BZA Application No. 20711

2628 Martin Luther King Jr. Ave., SE
2628MLK LLC
May 11, 2022

Overview and Requested Relief

Agency Conditions

1 PROPOSED SITE PLAN
1/8" = 1'-0"

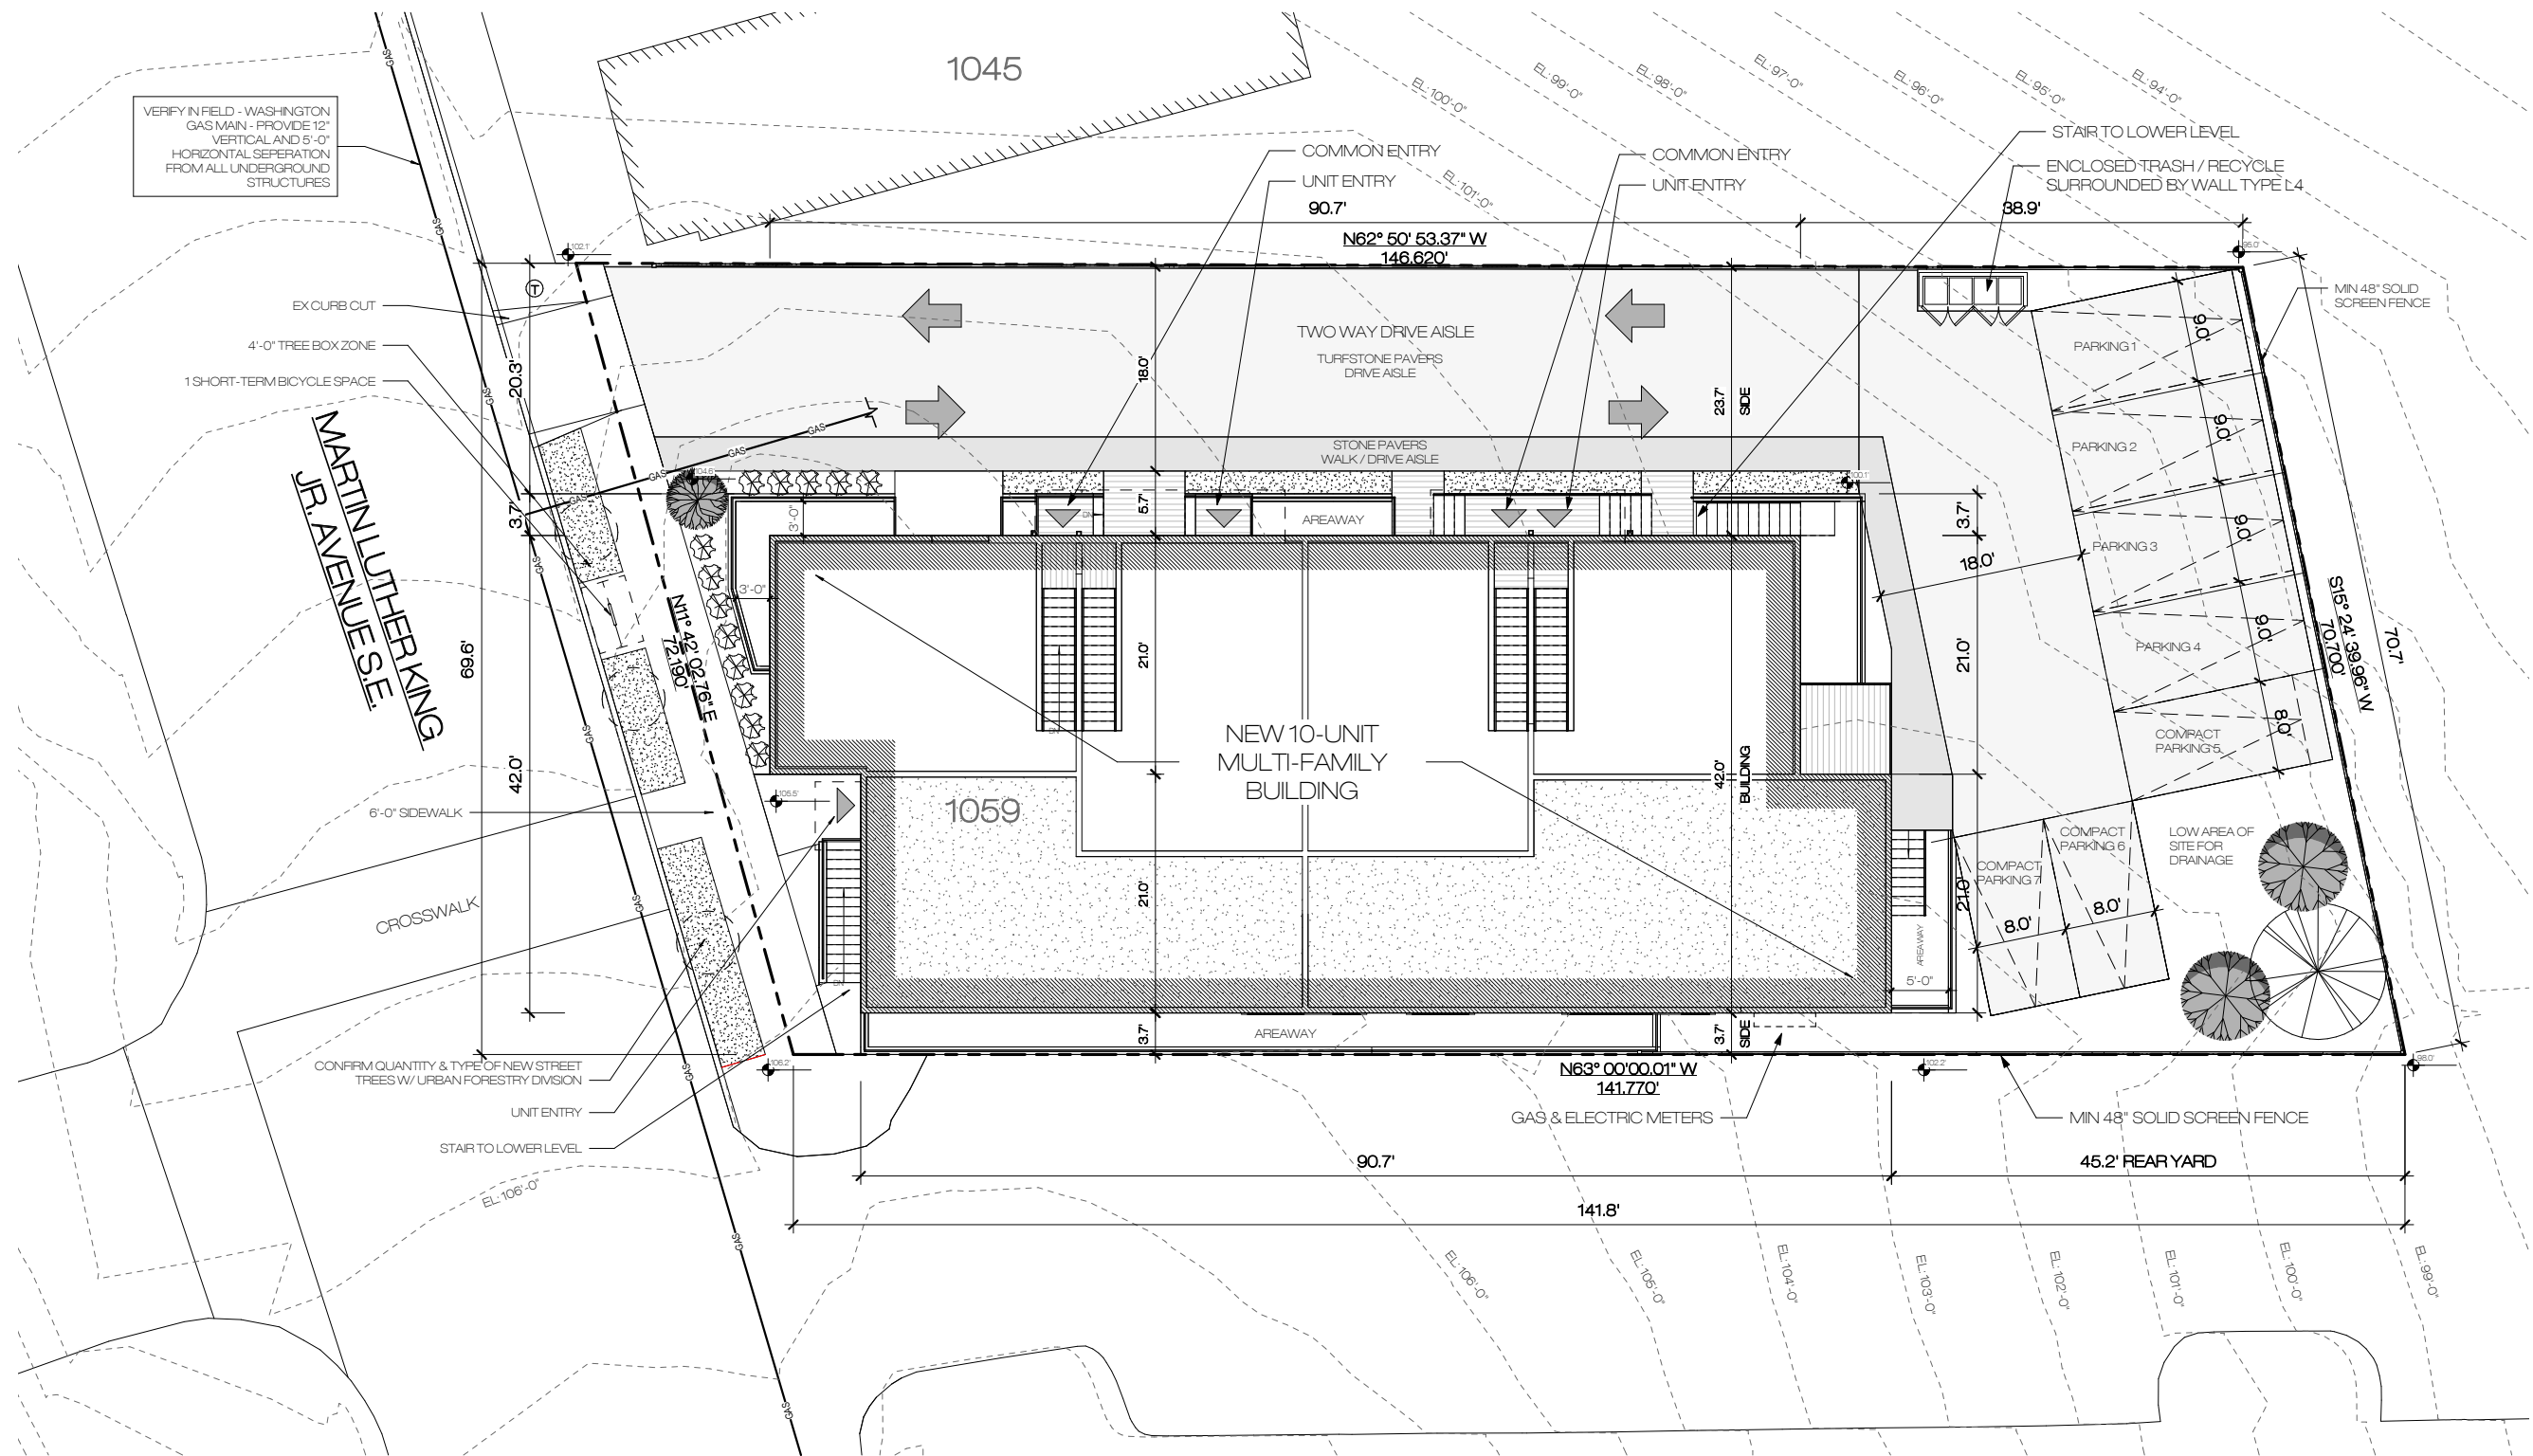
- The sidewalk area is shown as only 6-feet wide. This is narrower than DDOT's standard 10 feet combines sidewalk and treebox area. The plans should be updated to show a 4-foot treebox zone and 6 foot sidewalk, consistent with the properties to the south; **Plans have been adjusted to show a tree box and sidewalk consistent with properties to the south**

- The Applicant is proposing a 20-foot driveway to Martin Luther King Jr Avenue SE. The Zoning Commission recently approved a Text Amendment(ZC 21-10) reducing the minimum drive aisle width requirements (Subtitle C § 711.6.a.) to only 18 feet to match DDOT's commercial curb cut standards. Since the site will only have seven (7) vehicle parking spaces, the driveway should be narrowed, and amount of pavement reduced. This will also better align the driveway and curb cut to minimize the transition area near the property line; **Plans have been adjusted to show an 18 ft. driveway**

1 CELLAR LEVEL PROPOSED
 1/4" = 1'-0"

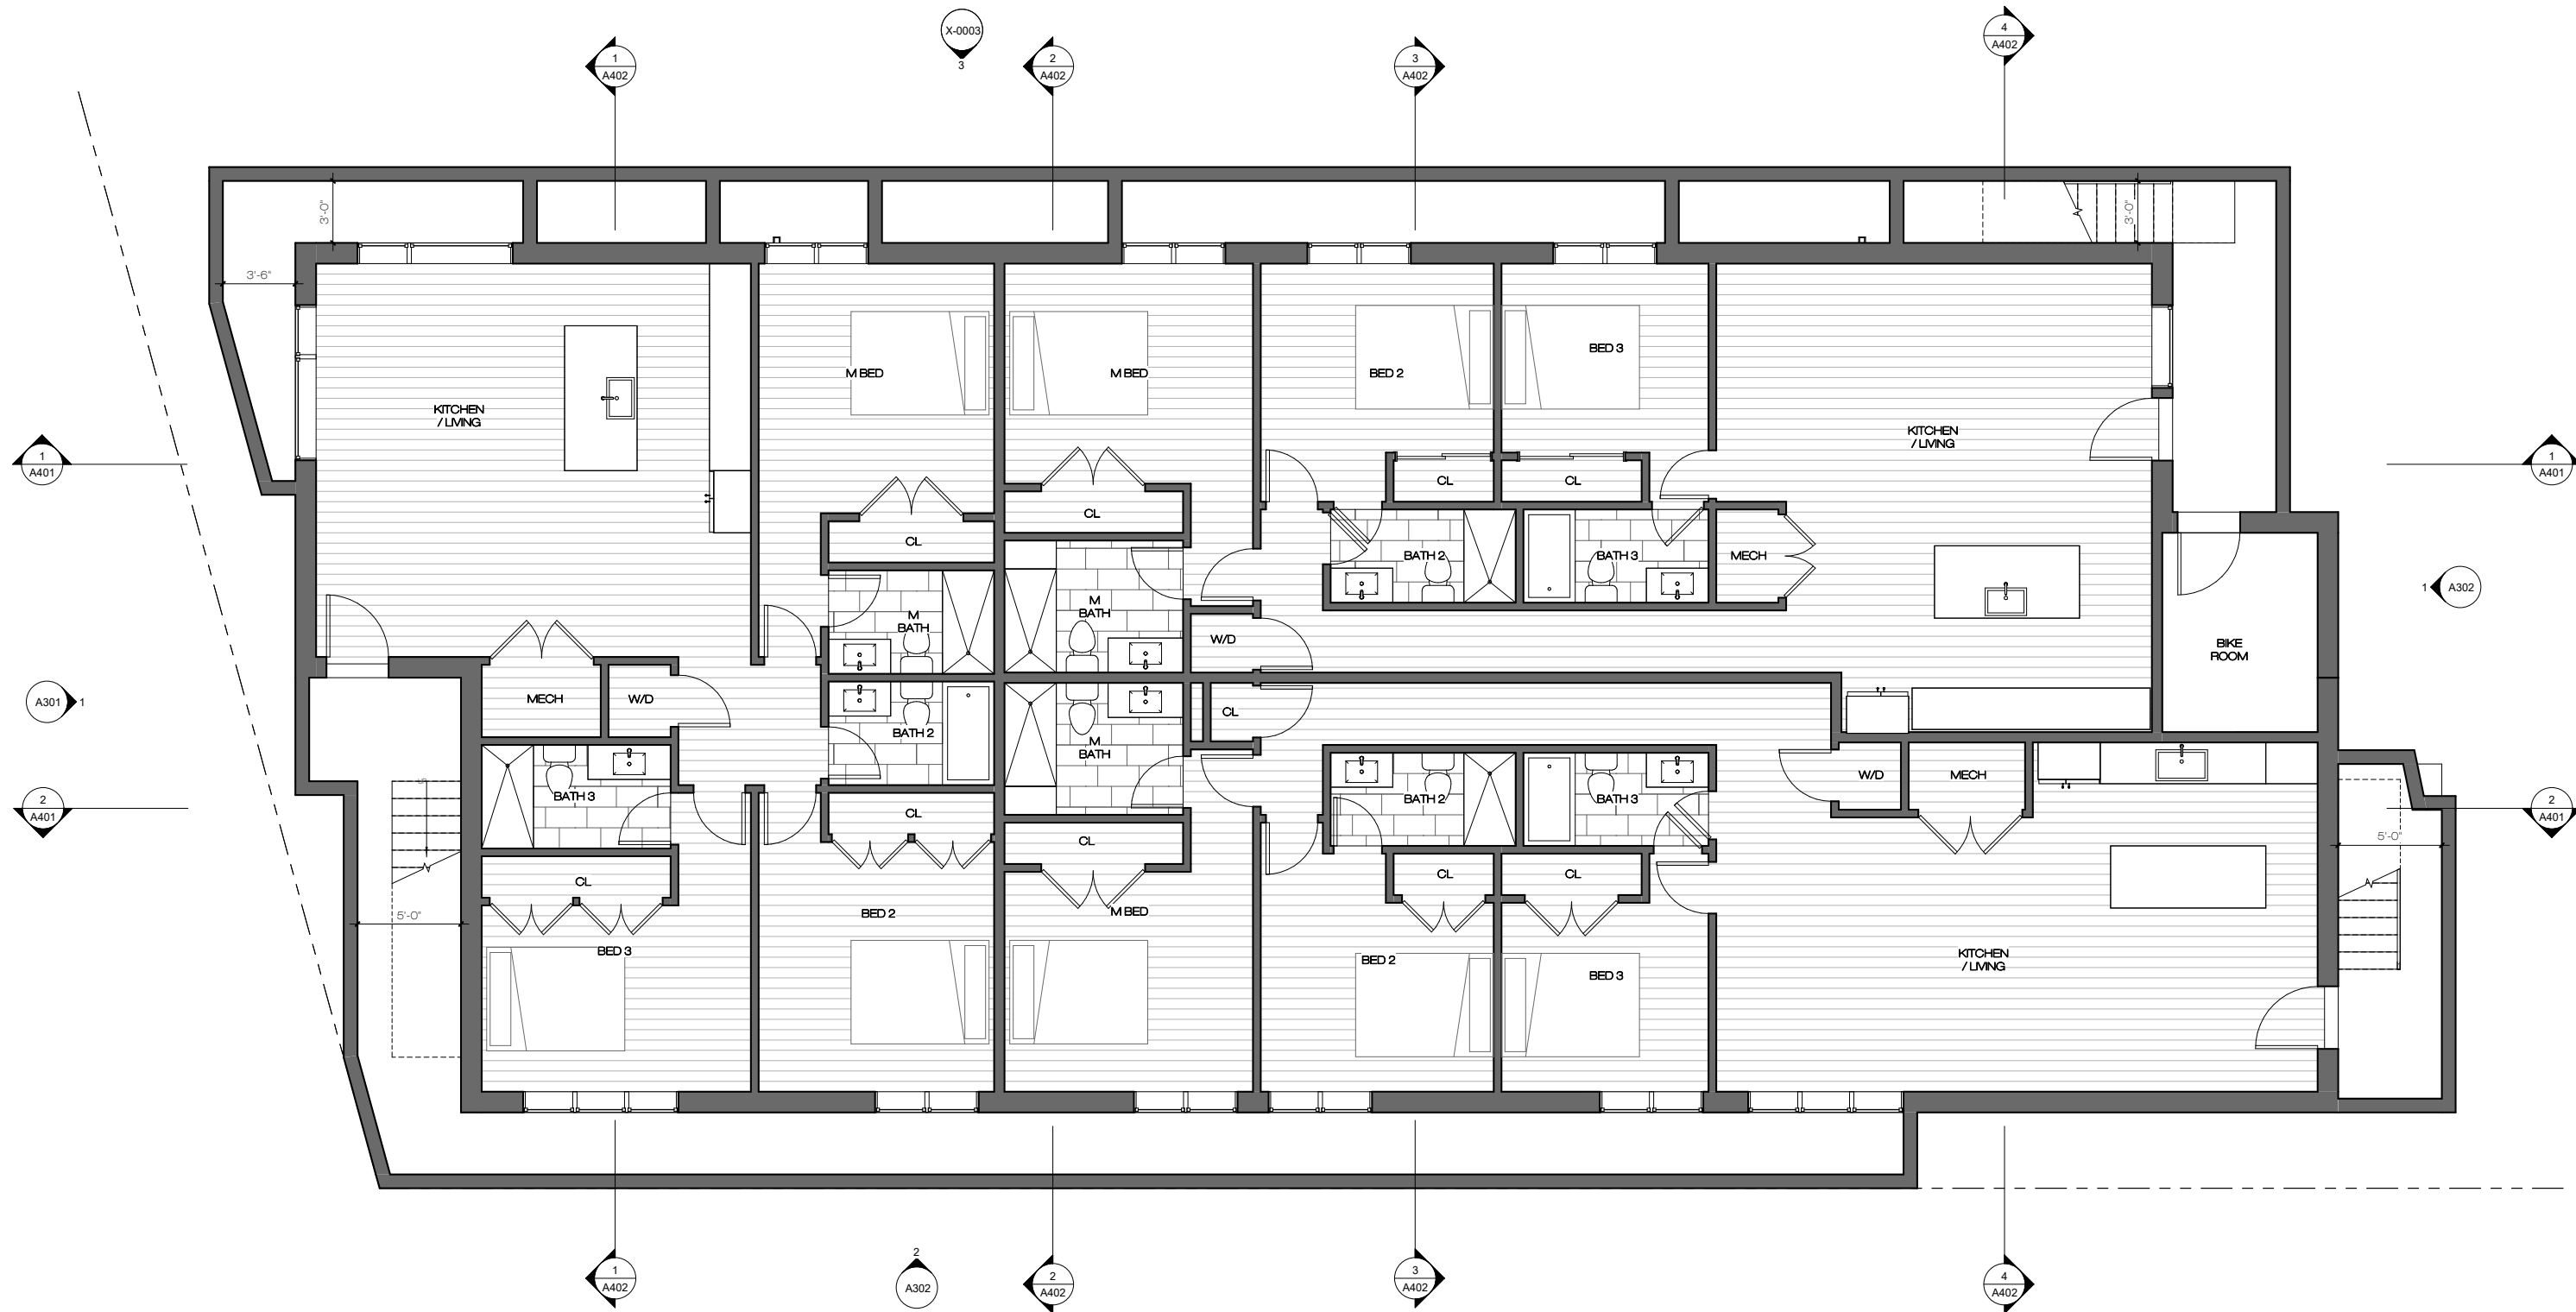
- The Applicant's submitted plans do not show that long-term bicycle parking spaces have been designed into the project. DDOT estimates zoning would require three (3) long-term bicycle parking spaces. **Bike Parking room shown with 4 spaces (3 required)**
